ST. TAMMANY PARISH

Addendum No.: 2

Bid#: 24-35-2

Project Name: Diversified Water Well Pretreatment System

CHEMICAL FACILITIES PLAN AND
ELEVATION

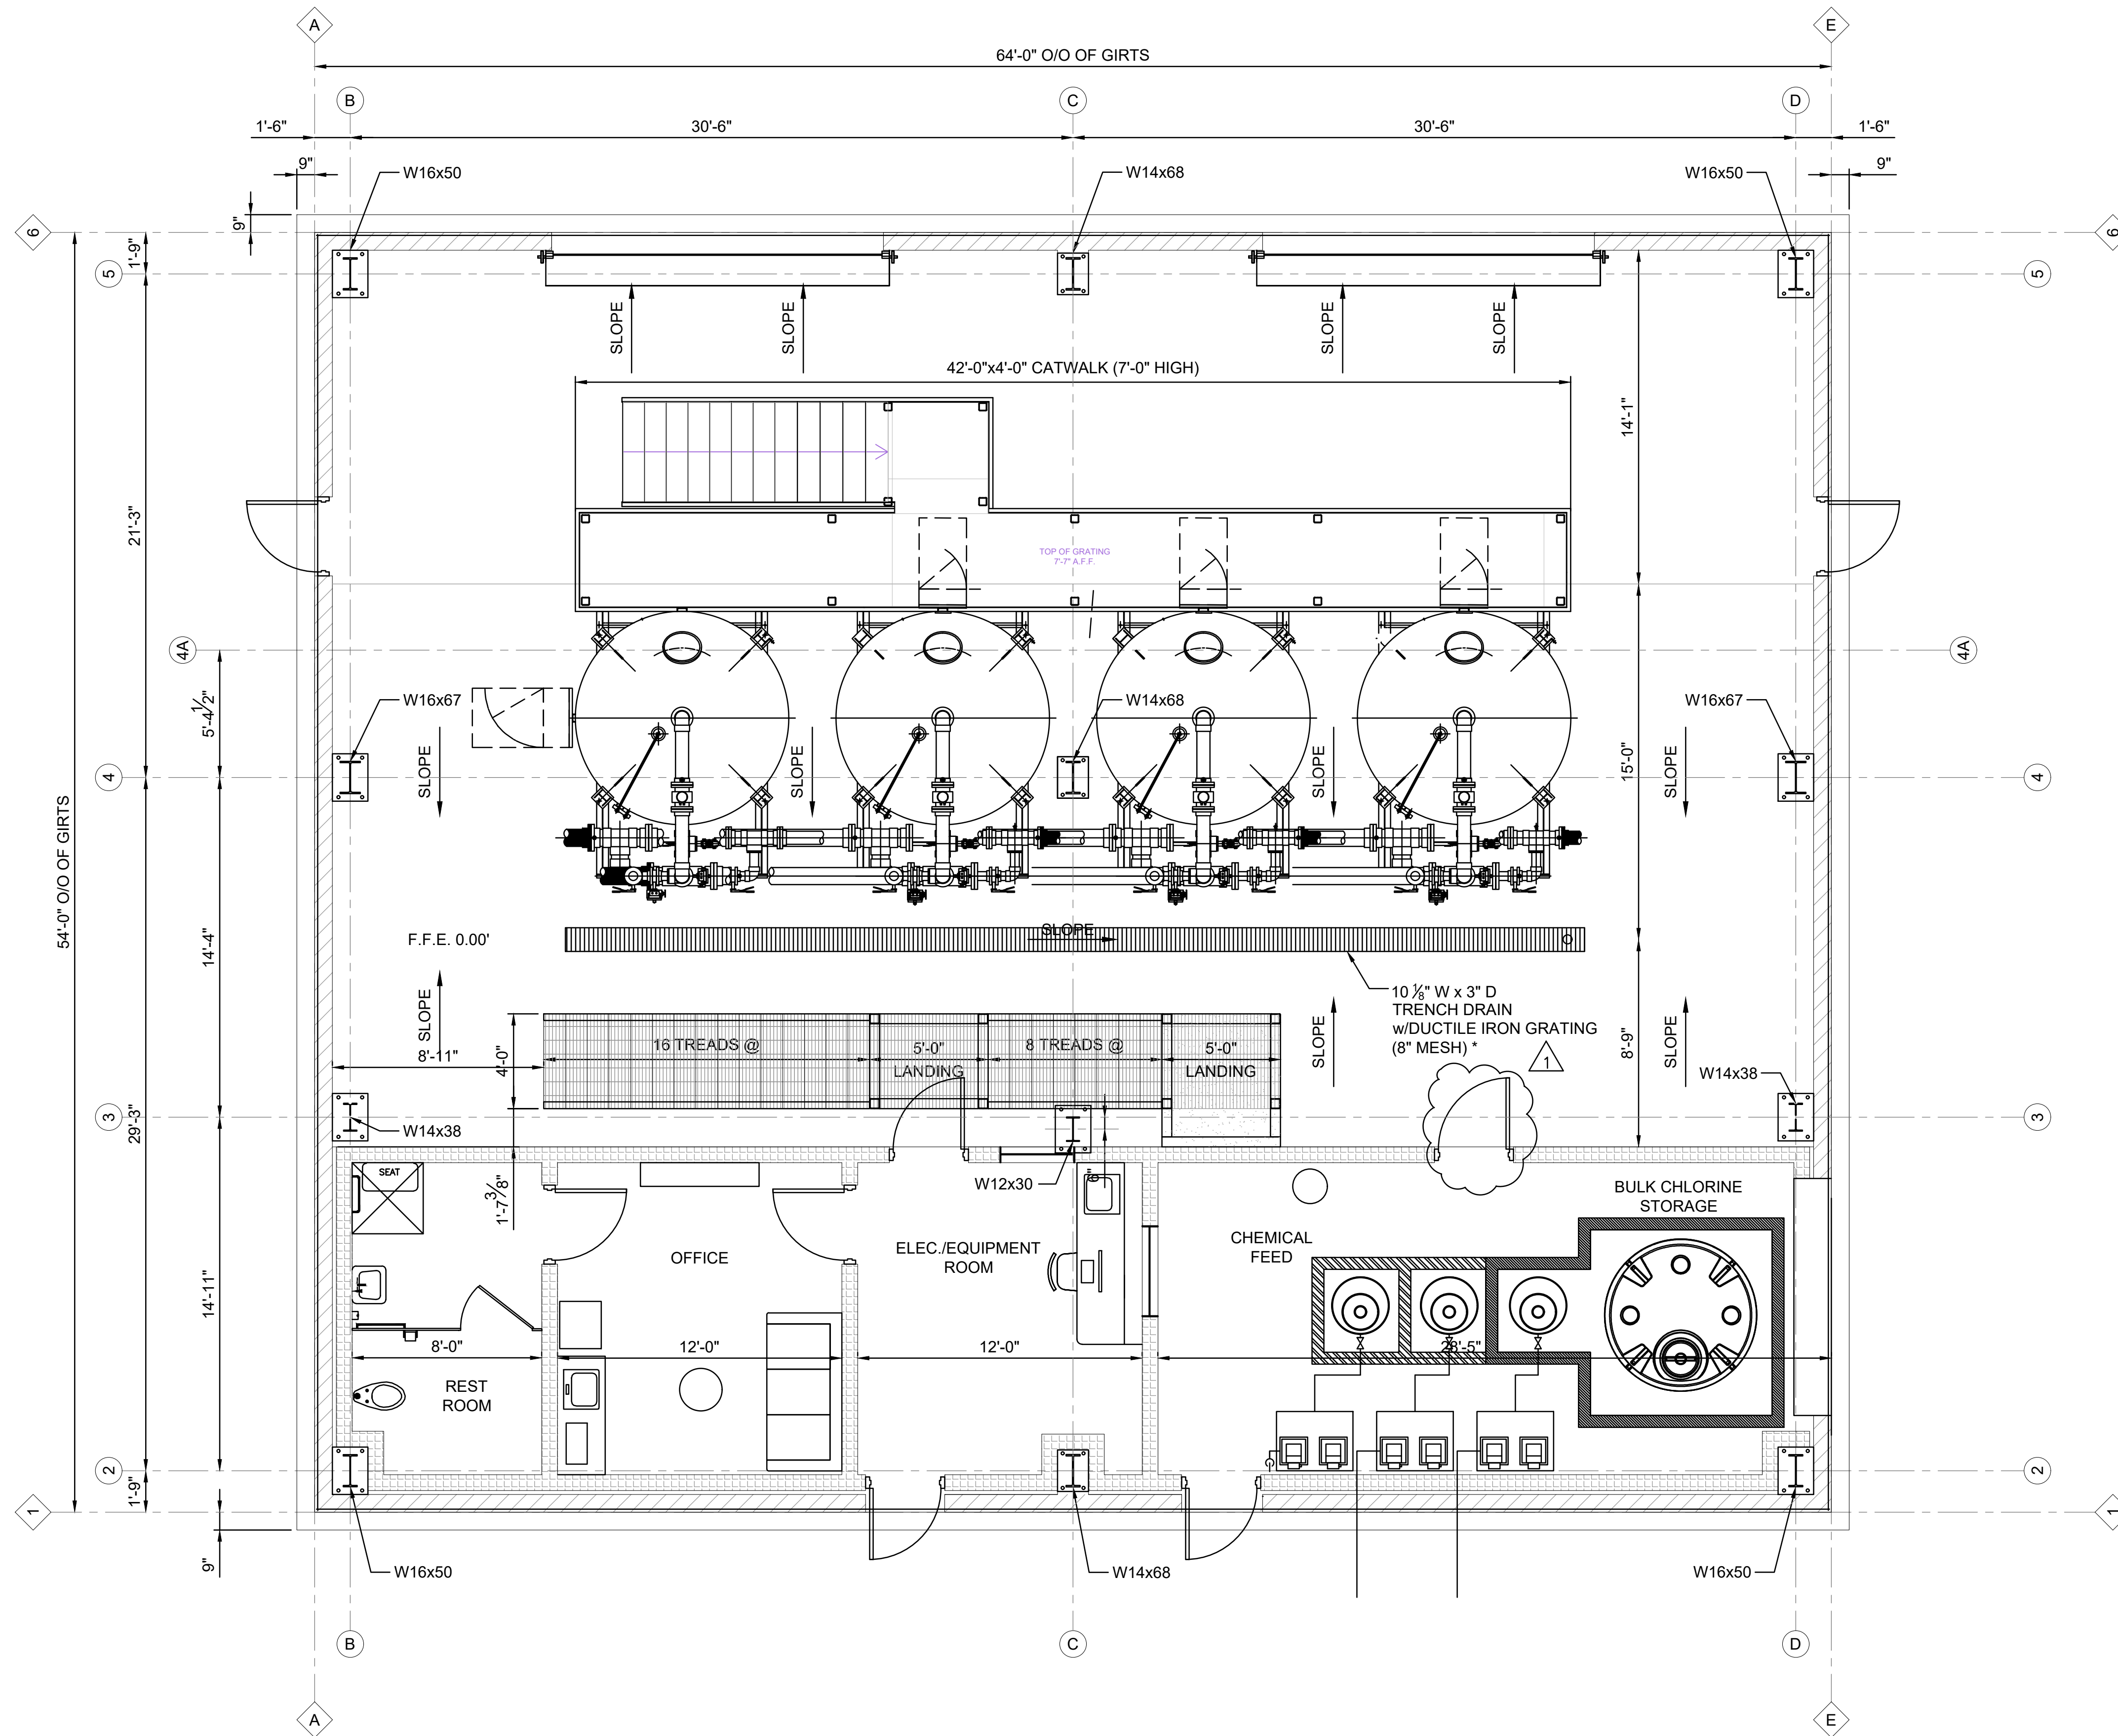
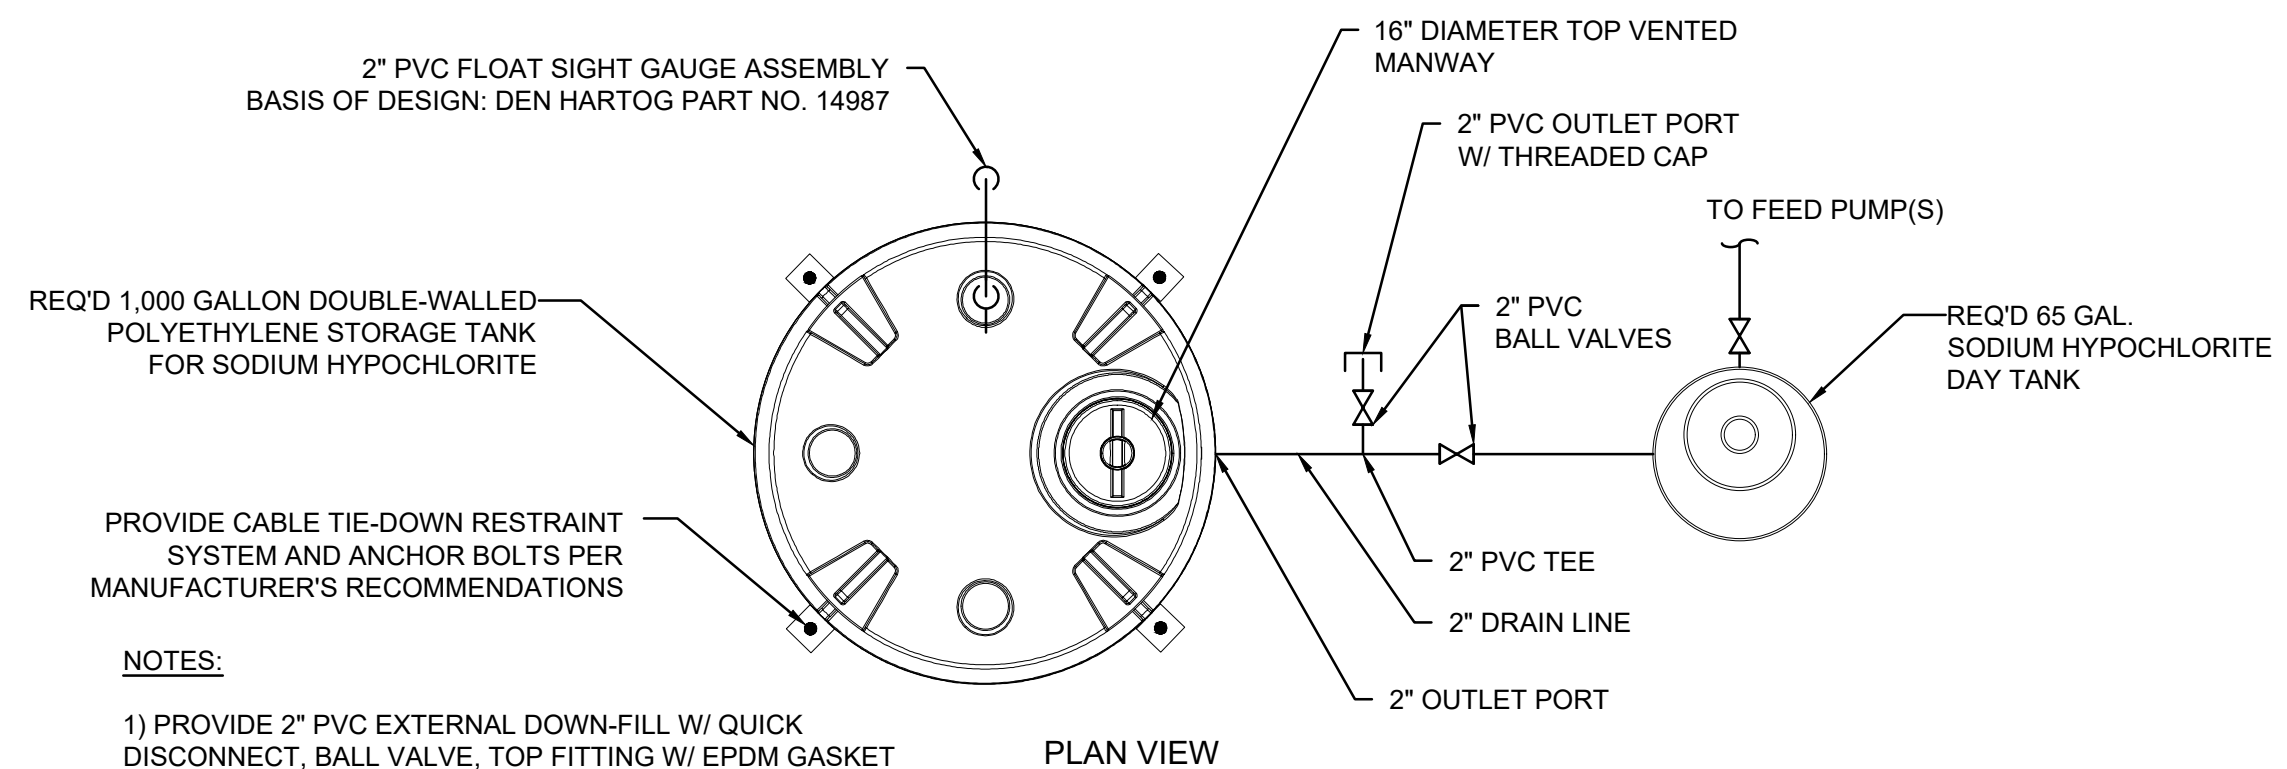
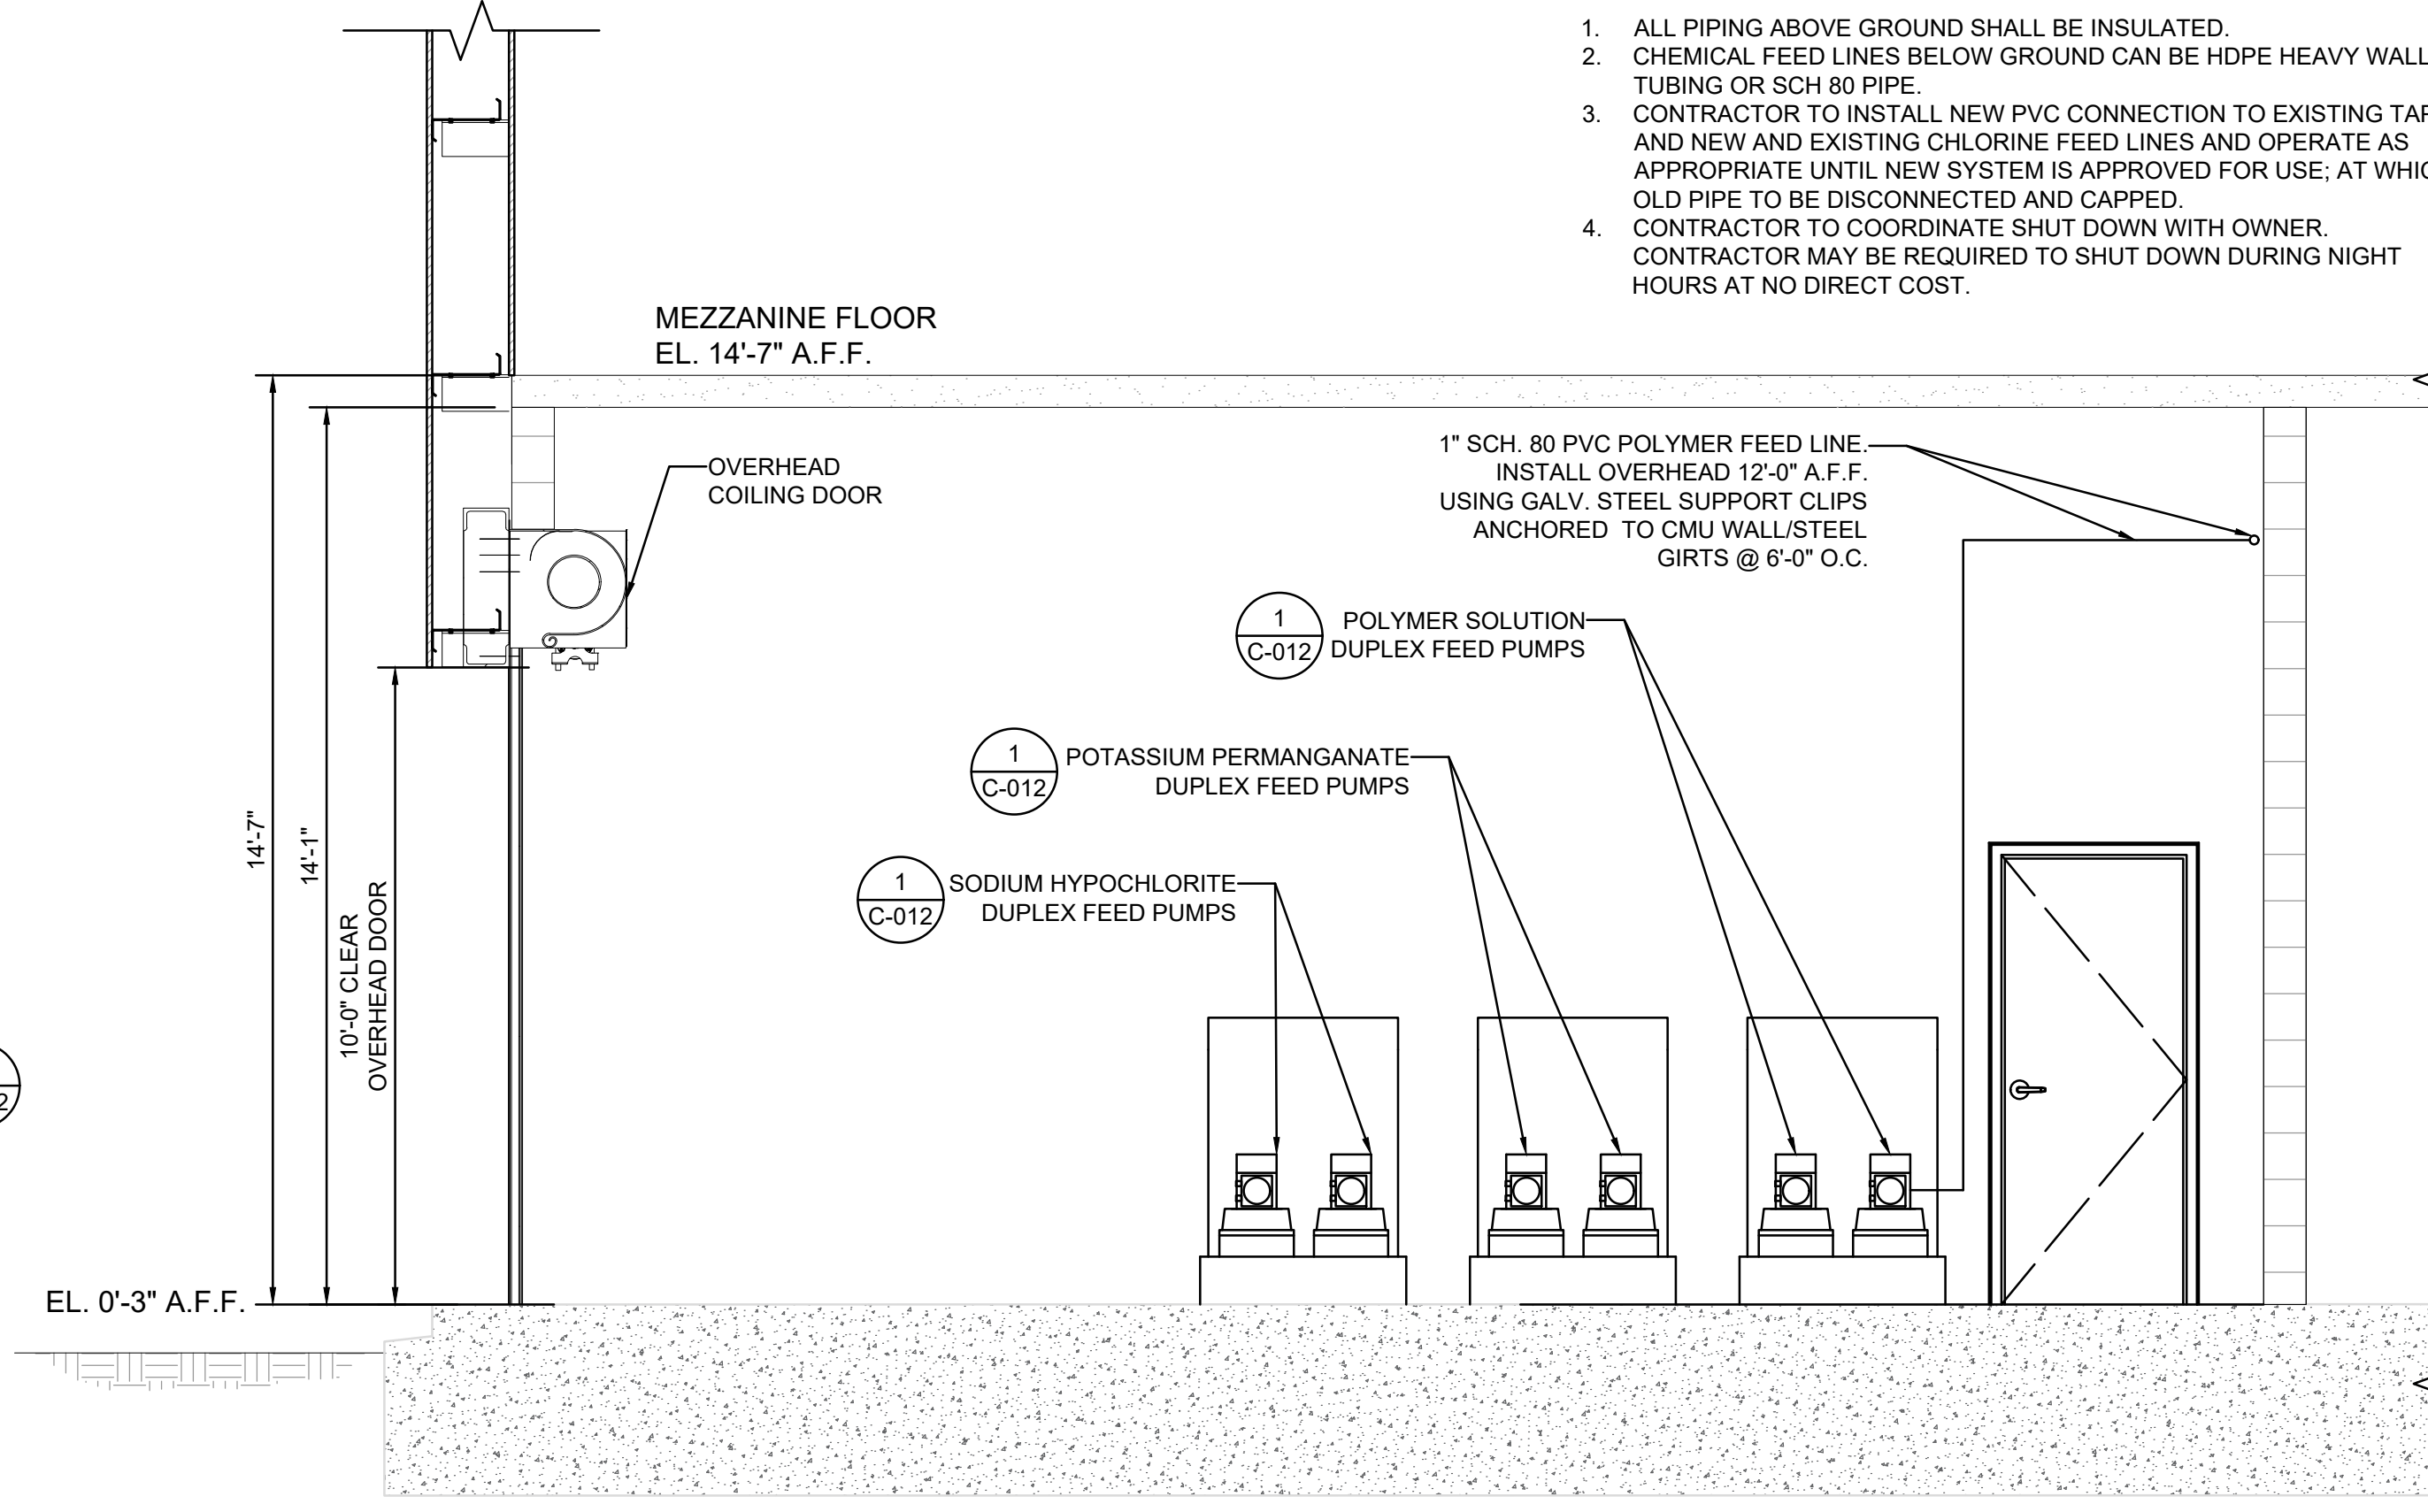
36. **Replace** Plan Sheet C-011 Chemical Facilities Plan and Elevation with the attached revised Sheet C-011, showing the revised location of Door #102B in the Chemical Feed Room, the addition of fiberglass floor grating on the chemical room floor, and the 12,000 BTU mini-split A/C system is deleted from the project.
